# United States Patent and Trademark Office

APPLICATION NO.	FILING DATE	FIRST NAMED INVENTOR	ATTORNEY DOCKET NO.	CONFIRMATION NO.
10/530,211	04/04/2005	Arnold Keller	246472007600	9918
25227 MORRISON &	7590 11/09/2007 & FOERSTER LLP		EXAMINER GANESAN, SUBA	
1650 TYSONS	BOULEVARD			
SUITE 400 MCLEAN, VA	22102		ART UNIT	PAPER NUMBER
		•	3774	
•				
			MAIL DATE	DELIVERY MODE
			11/09/2007	PAPER

### **DETAILED ACTION**

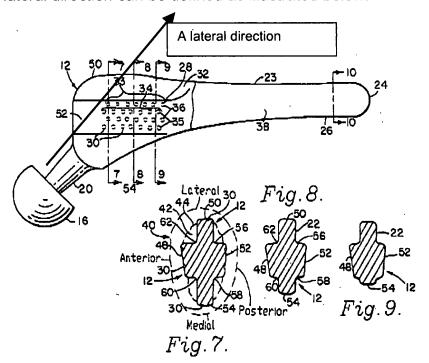
1. Applicant's arguments filed 8/29/2007 have been fully considered, however they are not persuasive. The examiner disagrees with the applicants' characterization of the Bohn reference, specifically that the Bohn reference does not show that the medial flank deviates away from a direction of a longitudinal axis of the shaft. Examiner disagrees because the medial flank 58 of Bohn tapers distally, as seen in the series of cross-sectional views of figs. 7-8. This tapering defines a medial flank that deviates away from the long axis of the shaft.

Applicants' argument that Bohn does not disclose the height of the fins decreasing in a lateral direction from an edge delimiting the steep flank is not persuasive. *A lateral direction* can be defined as illustrated below.

Such a selection of 'a lateral direction' in the Bohn reference is proper because the phrase 'a lateral direction' does not necessitate that the direction must be exactly perpendicular to the long axis of the stent, but rather that the direction selected is directed towards the lateral side of the prosthesis. With a lateral direction selected as illustrated, the height of the fins is decreasing in a lateral direction due to the tapering of the fin (which can be seen in figs. 7-9).
